Section 75W Modification Application Environmental Assessment Report

Central Park

Modification to Approved Concept Plan MP 06_0171 (Mod 8)

December 2012 ■ 12373

Figure 2 – Amended Public Domain Plan

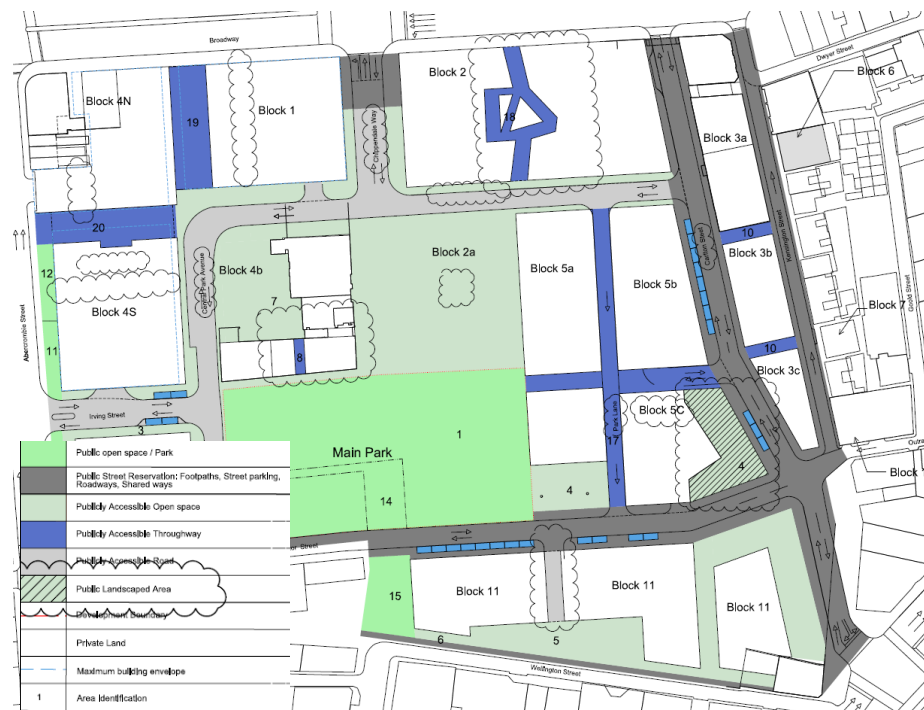
Figure 2 shows the revised Public Domain Plan. Some minor modifications have been made to reflect the revised design of Blocks 1, 4N and 4S. Several other changes are highlighted to pick up modifications which have been approved as part of separate Project Applications, including minor changes to Block 2 and the Brewery Yard. This includes a modification to the publicly accessible throughways between the Clare Hotel and Administration Building on Block 3A. It is noted that the intention of these areas was never to provide a formal through-site link between the buildings, rather, it was imposed to ensure that the Clare Hotel and Administrative Building could be read as two distinct elements (this requirement has been incorporated into the design through the provision of a glazed linking structure). The changes also include a modification to the public domain around Block 5C, which is proposed to change from a publicly accessible open pace, to a public landscaped area. This change has been made in consultation with the City of Sydney Council, in an attempt to discourage antisocial behaviour in this area.

Figure 3 – Approved (red) and proposed (grey) Block 1 and 4 envelopes

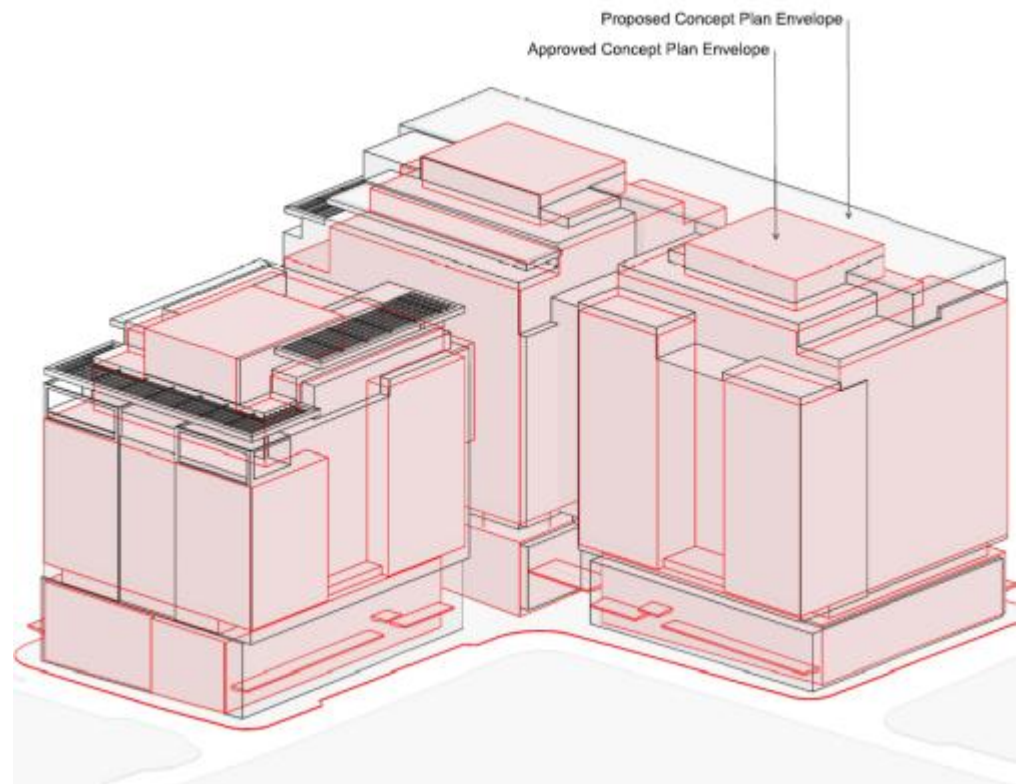
The approved and proposed envelopes for Blocks 1, 4N and 4S are shown at **Figure 3**. As discussed below, the revised massing remains generally consistent with the Concept Plan approval, and the key design objectives.

The proposed changes to the approved Block 4S envelope will facilitate the change of use from commercial offices to student accommodation. The revised envelope maintains the City Datum Line (with a recessed expression in the envelope that relates to the height of the Australia Hotel) and will ensure that there will be no additional overshadowing of the Main Park or properties along Abercrombie Street at key times of the year.

The changes to the Block 1 and 4N envelope responds to current trends in commercial office design, which typically require a large floor plate with

maximum connectivity. The proposed modifications will enable more efficient floor plates, and a massing that is more sympathetic to the adjoining Block 2 development, whilst maintaining the key concept of the City Datum Line, which has been maintained around the perimeter of both Block 1 and 4N.

Further, the proposed modifications to the Block 1 and 4N envelope are accommodated within the approved height, and do not affect shadows cast across the Main Park. This has been achieved by ensuring that the revisions to the massing of the northern elevation are contained within the underside of the approved solid canopy.
